Design Review Board Study Session

SUBJECT: DR14-42, COSTA VIDA MEXICAN GRILLED RESTAURANT

DR14-42, Costa Vida Mexican Grill site plan, landscape plan, grading and drainage, elevations, floor plans, lighting, colors and materials for a 5,353 square foot new building on approximately 1.1 acres located on the southeast corner of Market Street and Pecos Boulevard zoned Regional Commercial (RC) with a Planned Area Development (PAD) overlay (Crossroads Center).

LANDSCAPE PLAN

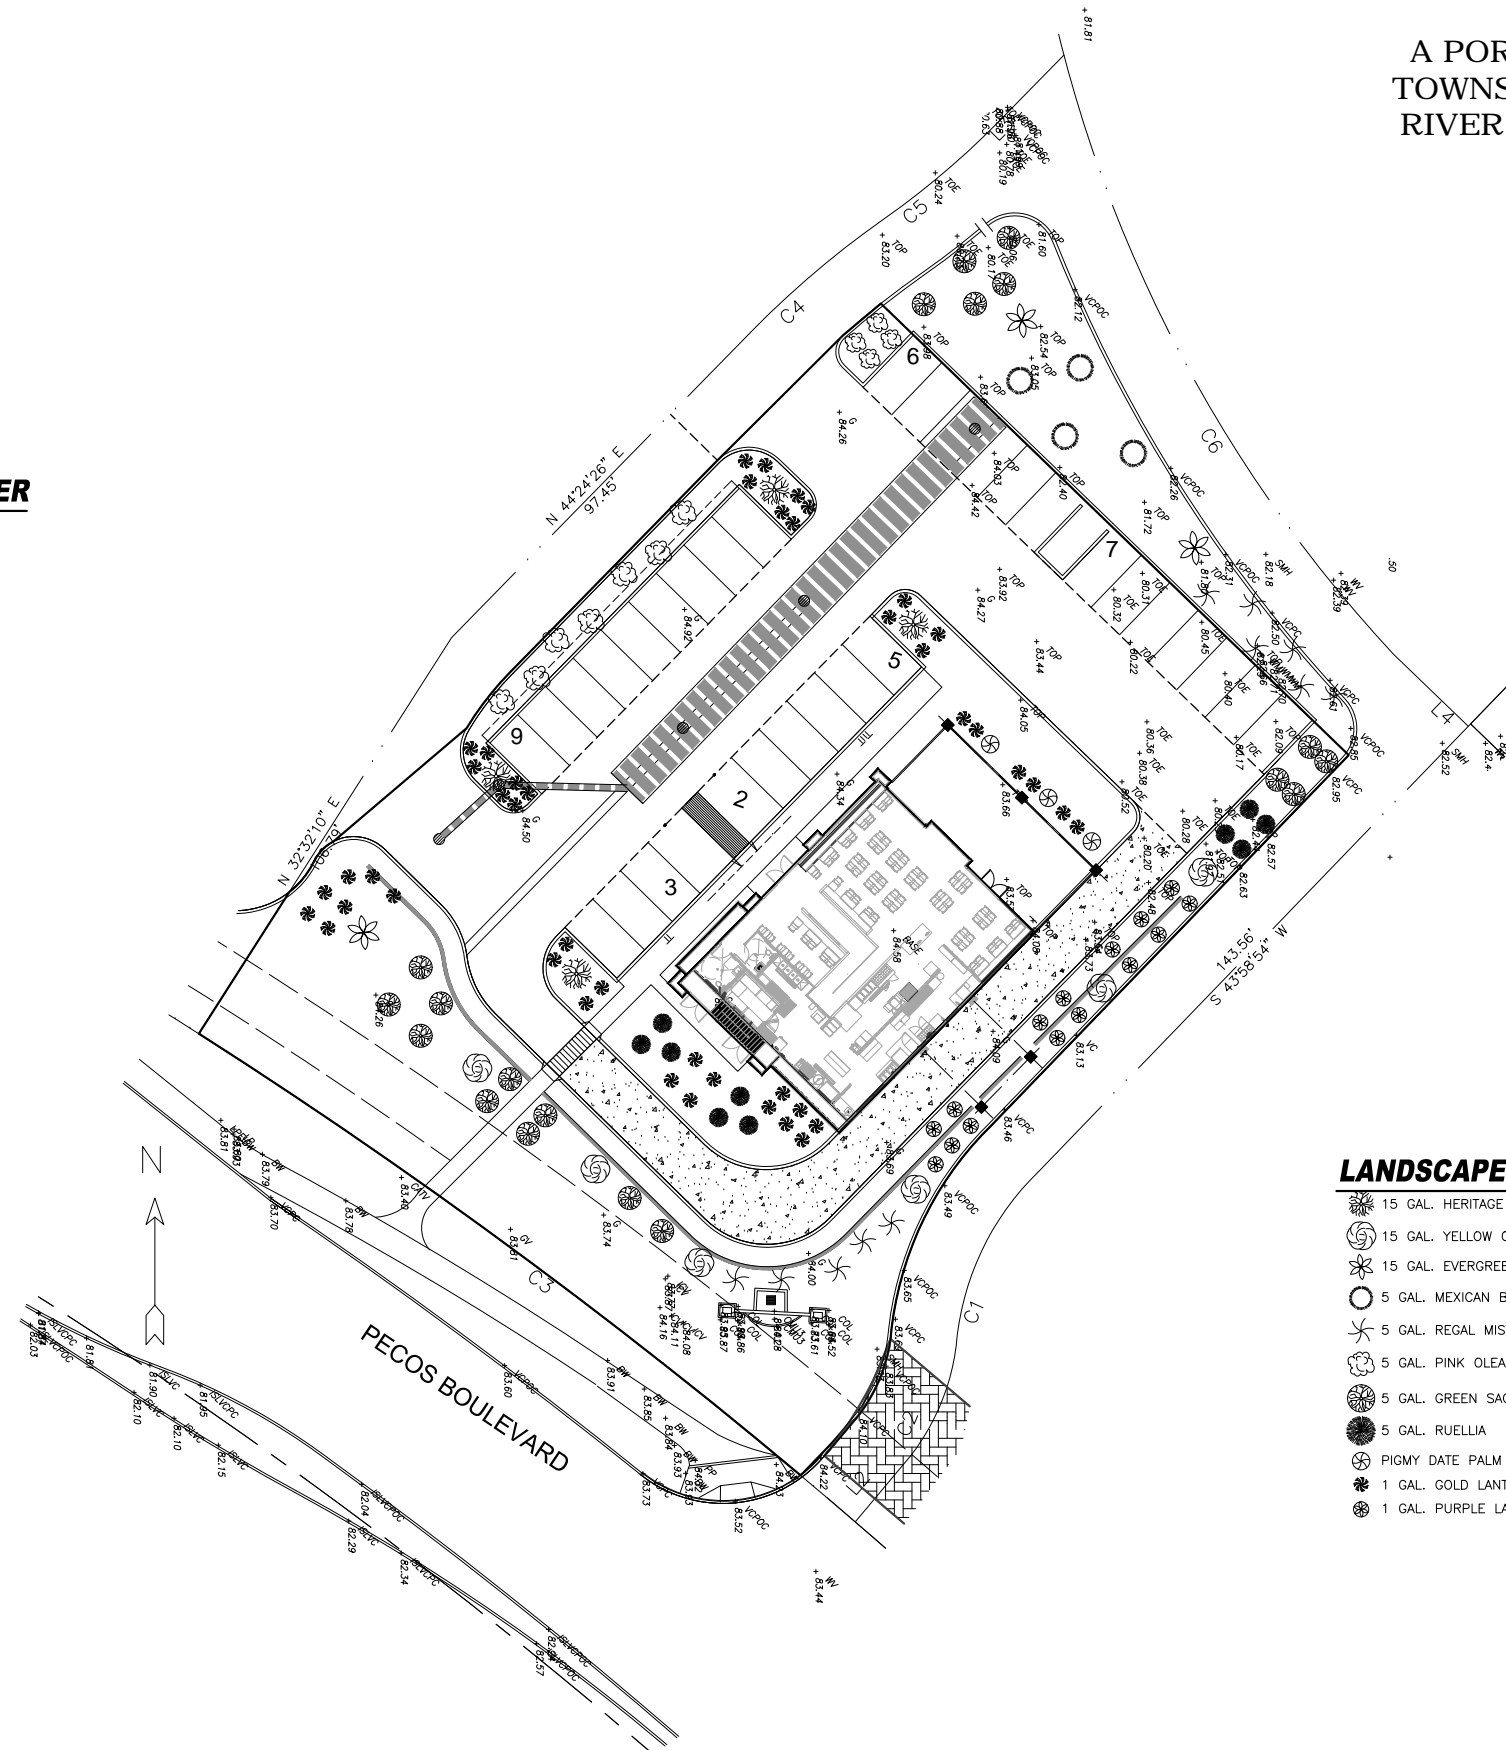
1. Landscape Plans: Development and Costa Vida will work together to verify planning materials and configuration in accordance with the SanTan Village PAD criteria.
2. Lighting Design: Developer and Costa Vida will work together to verify lighting materials to comply with the PAD criteria Booklet.

The application will not be scheduled for public hearing until the applicant resolves the landscaping plans and lighting design with the SanTan Development Group. An approval letter from SanTan Development Group along with the revised plans are to be submitted to the Town of Gilbert.

REAR ELEVATION
SCALE 1/8" = 1'-0"

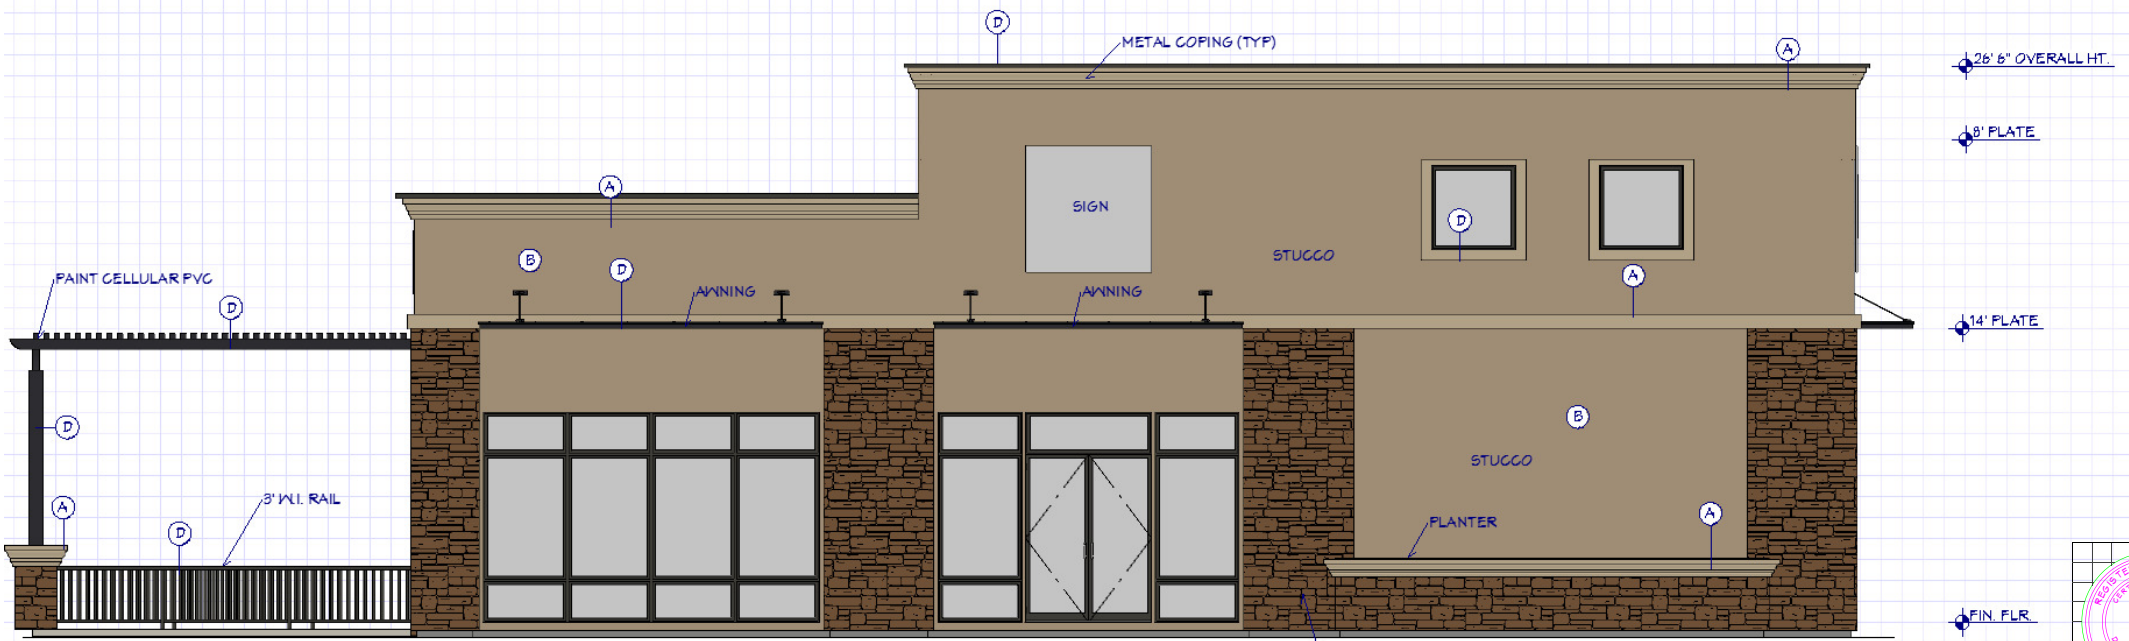
The rear and left elevations also meet the criteria of the design guidelines with a change of building height, change of color and material and articulation. On the rear elevation, the parapet extending above the roof line and visible to the public will need to be painted. The applicant shall locate the roof mechanicals such they are not visible from the public view.

FRONT ELEVATION
SCALE 1/4" = 1'-0"

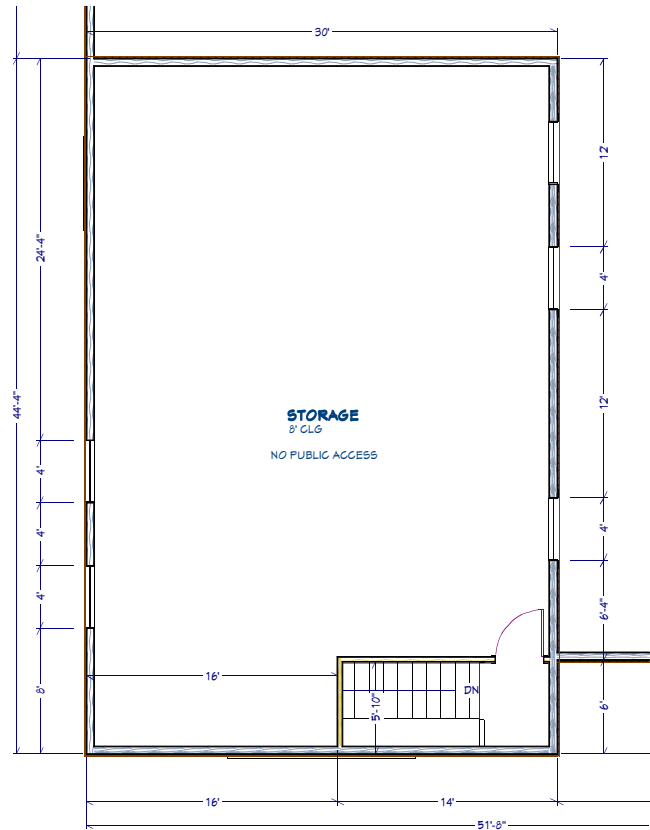
The front elevation has been improved with repetitive and consistent window patterns, an identifiable front entry with a proposed sign above a metal awning and a front door. The applicant also improved the front elevation by removing a service door and placing a planter and a wall area that could potentially be used for signage or art.
